Q3: Can you show us results from ProtoDUNE-I in-situ calibrations?

Q10. (S) For the LED calibration system:

Diffuser Aging Studies

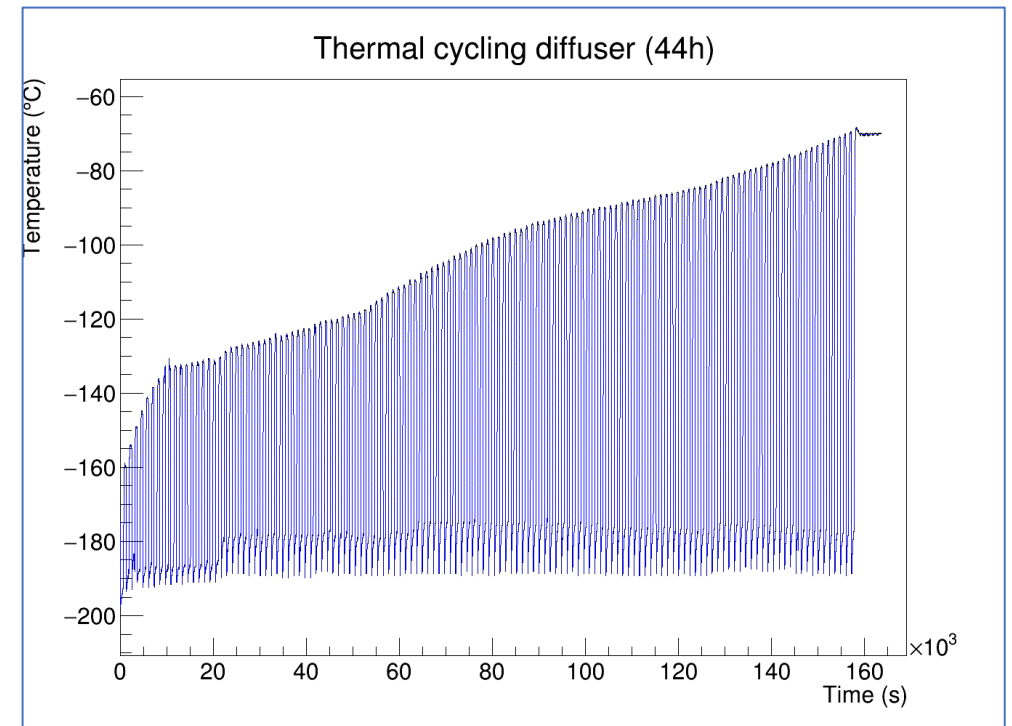
(ii) the diffuser mounts are 3D printed, what aging tests have been done?

- Testing material: PEEK.
- Long time test: ~2 years (Feb. 2021) submerged in nitrogen (previous version of the design)
- In addition to the long-time test, we performed a LN2 thermal cycling test (warm up and cold down) during 44 hours
- No visible signs of damage in the 3D printed diffuser

Previous design tested during
2 years in LN2

Latest design installed in
ProtoDUNE HD

Pre-installation test

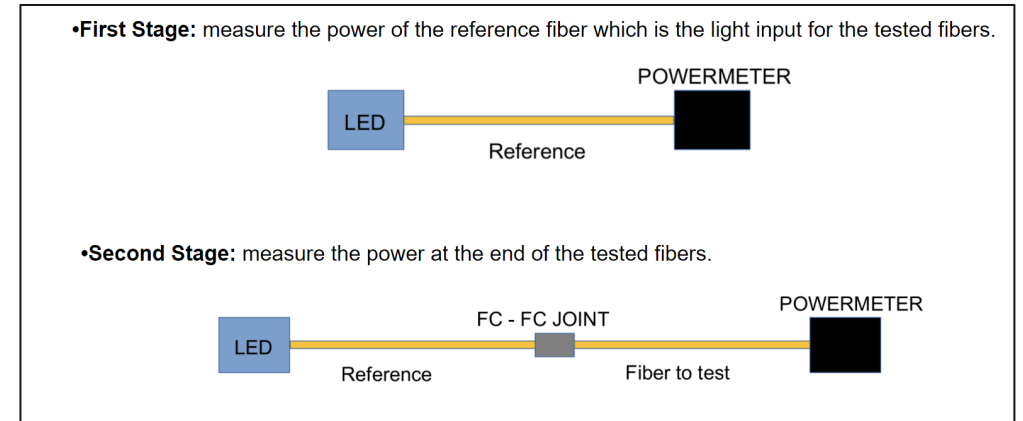
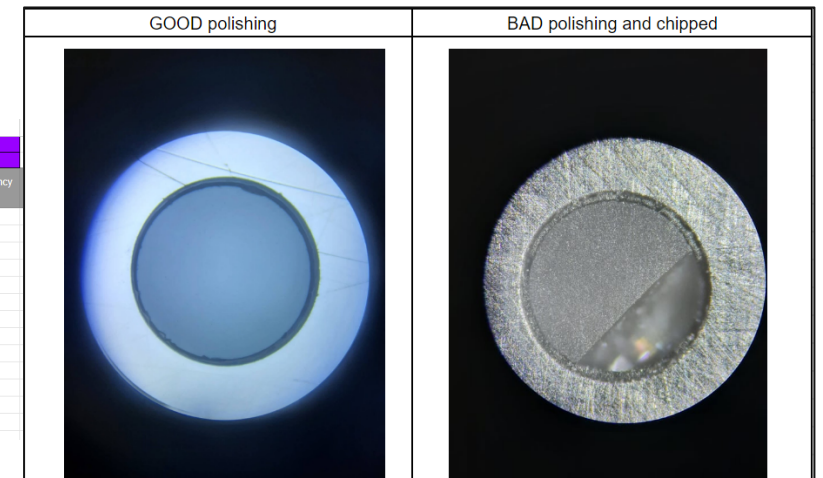
(i) Please give more specifics on QA/QC LED calibration system plan pre- and post-installation

- During the assembly of the fibers, multiple check were done to guarantee the quality of them.
 - **Transparency test:** The goal is keeping at the minimum the difference between the power input and power output in the tested fiber to avoid large attenuations
 - **Visual inspection:** Both ends are inspected with fiber inspection scope. If visible scratches are present, the fiber is not used.
